## VoyagerGX Rev. AA Errata Information

This document describes the errata information for the VoyagerGX (SM501) Rev. AA silicon. All the issues outlined in Errata for the earlier chip revisions have been fixed in Rev. AA silicon.

## AA-11. 8-bit Digital CRT and 8-bit ZV Interface Can't be Used Simultaneously

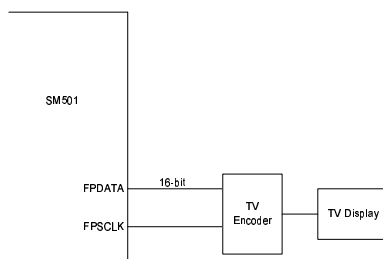
**Description:** When GPIO[63:56] are set to drive TV display, enabling the 8-bit ZV Port will cause TV display blank. However, enabling the 16-bit ZV Port will not cause TV display blank but the ZV capture image is incorrect or broken.

**Root Cause:** The definition of the 8/16-bit ZV Port interfaces between the Capture Control block and the internal MUX are reversed.

<u>Register 0x90000[9]</u>	<u>Capture Control Block</u>	<u>Internal MUX</u>
0:	16-bit	8-bit
1:	8-bit	16-bit

When 0x090000[9] is set to 8-bit ZV Port interface, the MUX considers it as 16-bit interface and enables GPIO[63:56] as input mode. Therefore, if GPIO[63:56] are driving TV display, enabling register 0x090000[9] for 8-bit ZV Port interface simultaneously will cause the TV display blank.

**Workaround:** Software Workaround: None. Hardware Workaround: select TV encoder that can be driven by the 16-bit FPDATA as showed in the diagram.
